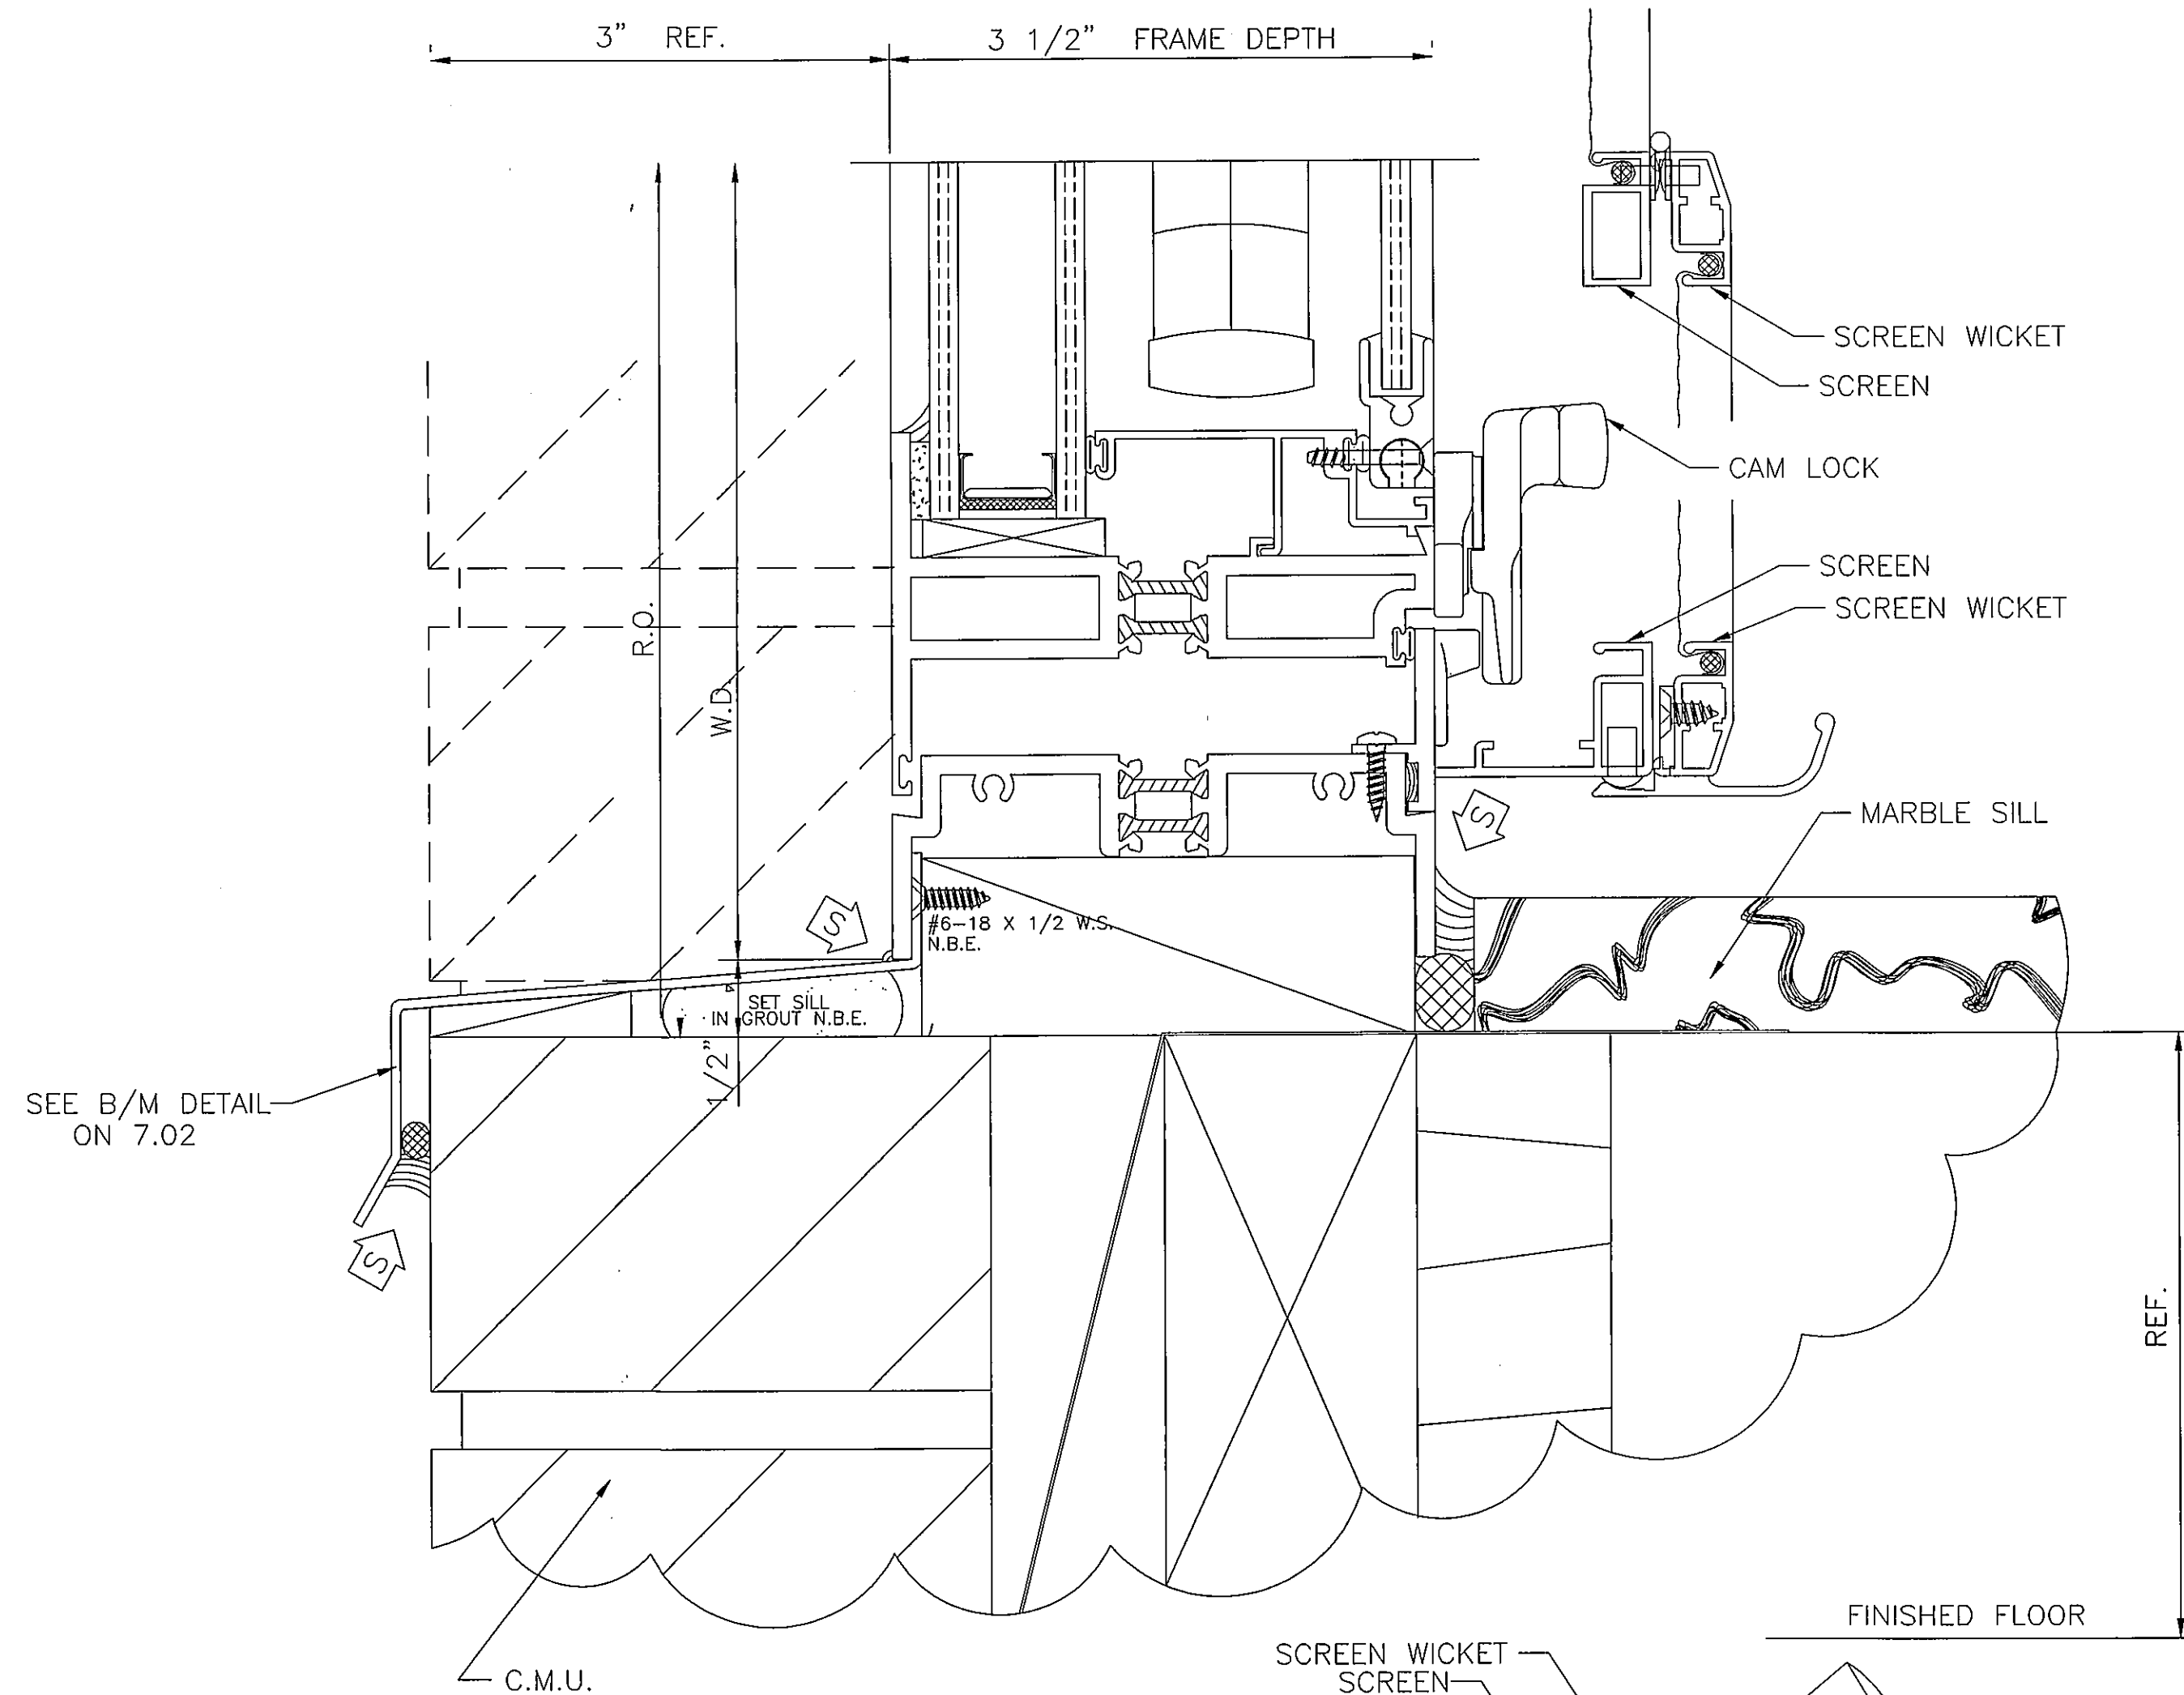
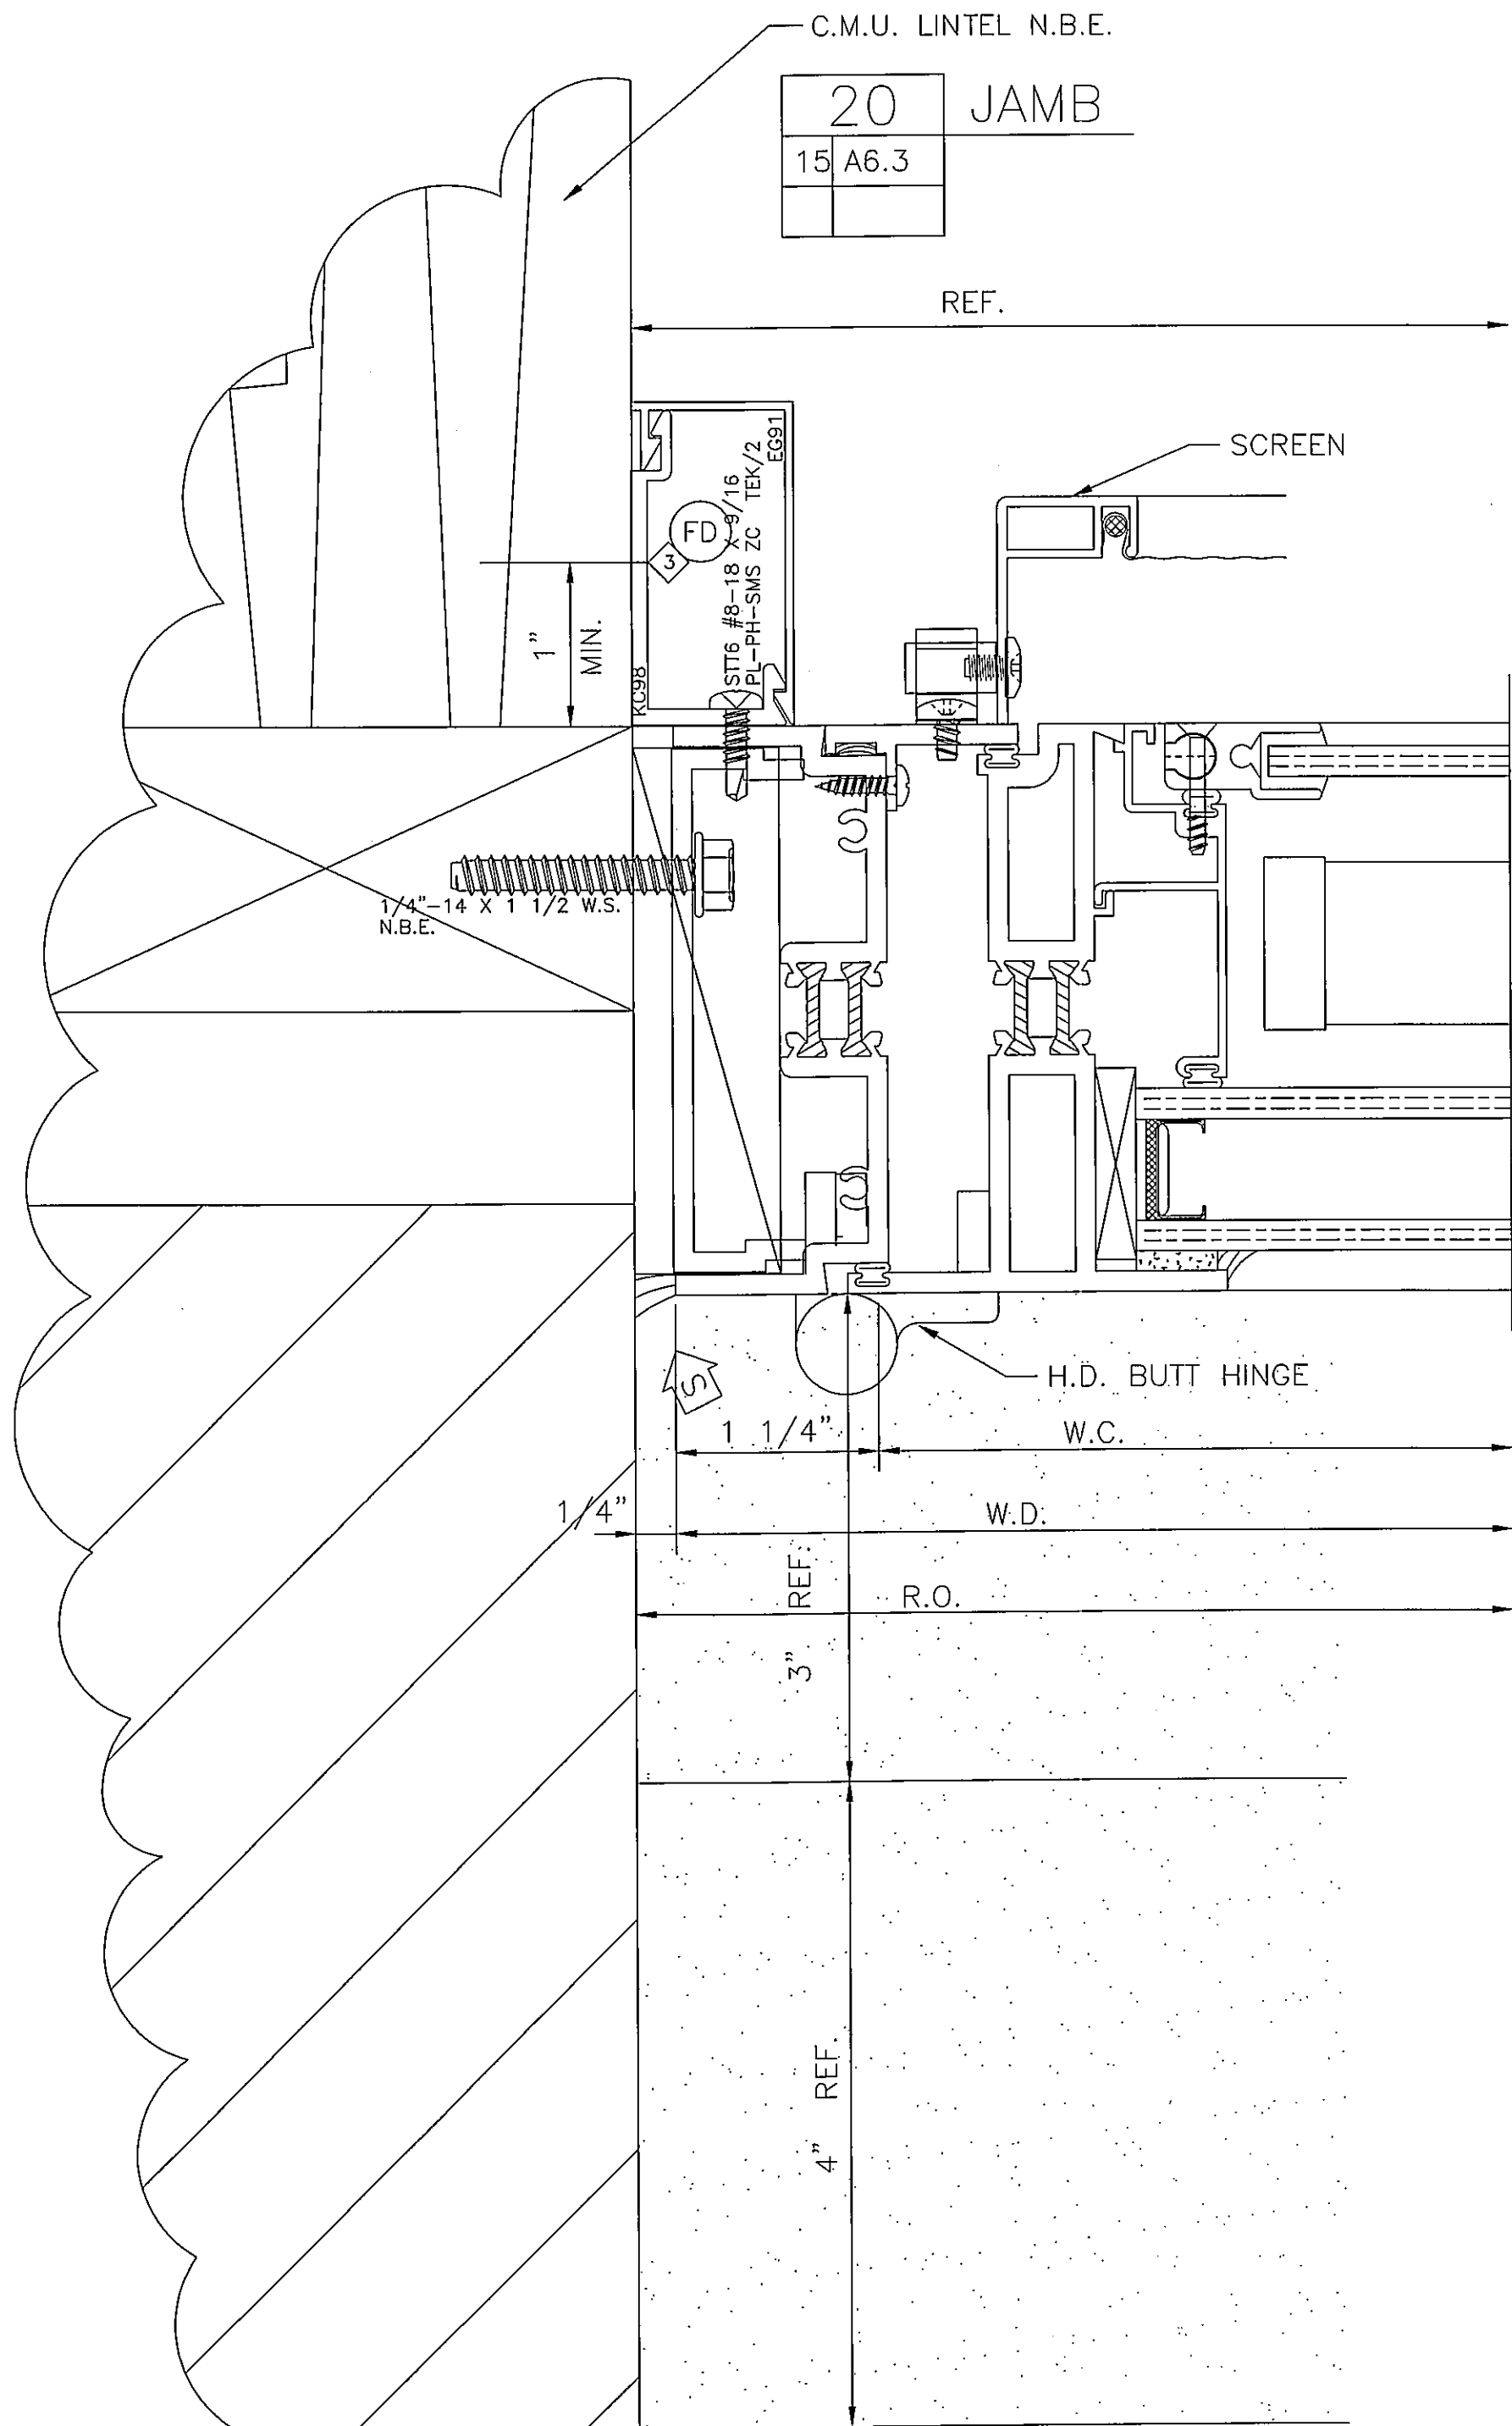
~~ARCHITECT'S NOTE:~~
~~EFCO DOES NOT HAVE AN ALTERNATIVE TO~~
~~THE SCREEN CONFIGURATION SHOWN ON THE~~
~~8101 WINDOW DETAIL AND ROTO'S.~~
~~PLEASE VERIFY THE USE OF THE CURRENT~~
~~SCREENS.~~

FOR SCREEN DETAIL
 SEE 10/704
